## Heritage Road *Roundabout Evaluation*

## Eagle Ridge Drive *Traffic Calming Evaluation*

January 2018

The Draft Heritage Road Roundabout Evaluation and Eagle Ridge Drive Traffic Calming Evaluation Report was completed in September 2017 by Bohannon Huston, Inc.

Table 7: Corridor-Wide – Final Recommendations

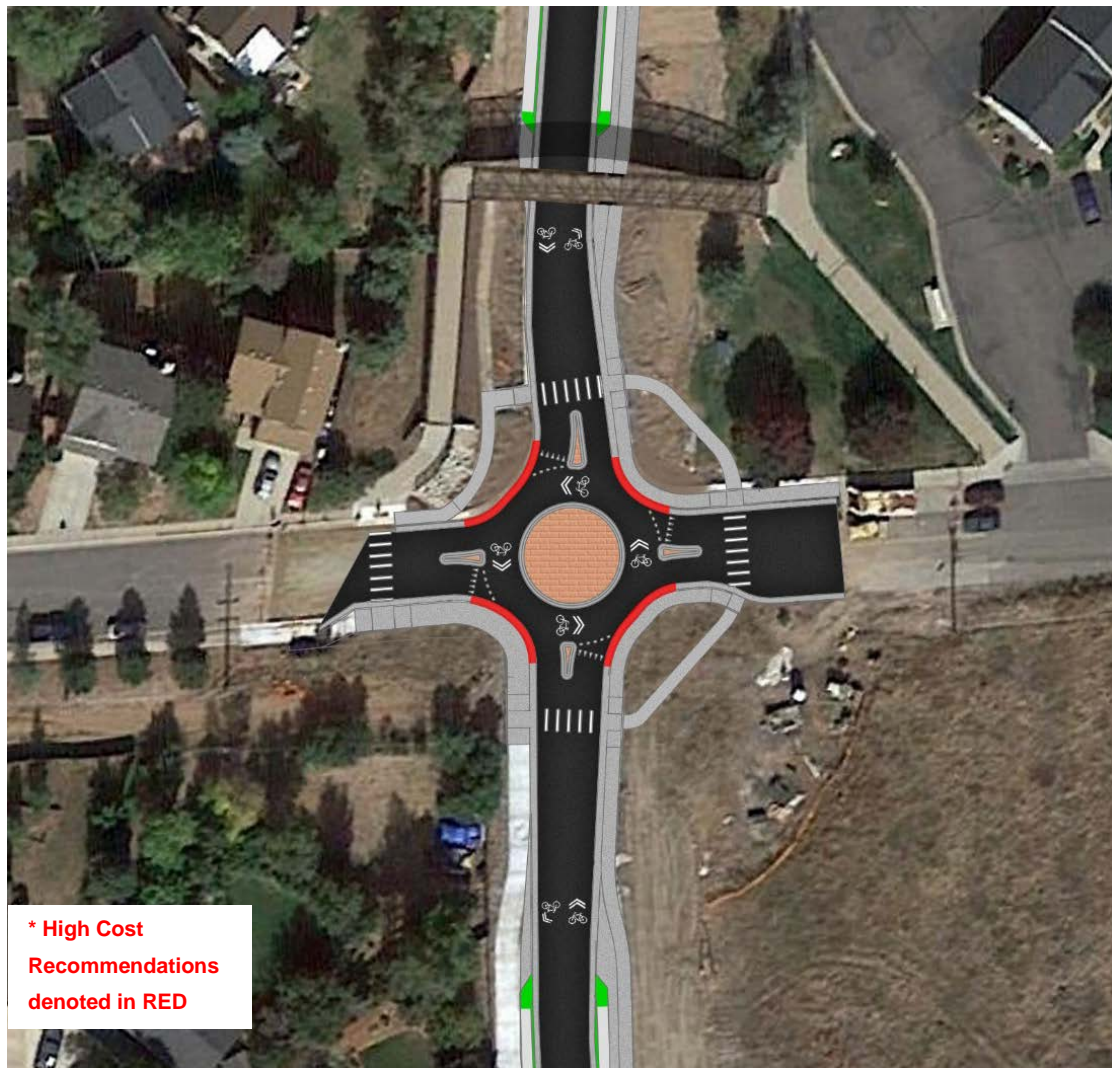
Corridor-Wide – Final Recommendations	
Low Cost	Consolidate signage along corridor to improve sightlines and promote consistency at each roundabout.
	Green paint and pavement markings at decision points - enter/exit - and along bicycle facilities. Sharrow markings through the roundabout.
	Enhance existing crosswalk markings with enhanced paint and additional hashmarks in crosswalks.
	Add sharrow pavement markings north of Eagle Ridge Dr.
	Place low landscaping options between sidewalks and bicycle lanes and/or traffic lanes, where applicable.
	Recommend lane narrowing in the northbound direction and addition of sharrow pavement markings.
	<i>New Recommendation: Consider improved lighting</i>
	<i>New Recommendation: Improved maintenance of bicycle lanes by the City</i>
	<i>New Recommendation: Improved signage prior to entering Heritage to notify trucks and large vehicles of the presence of roundabouts</i>
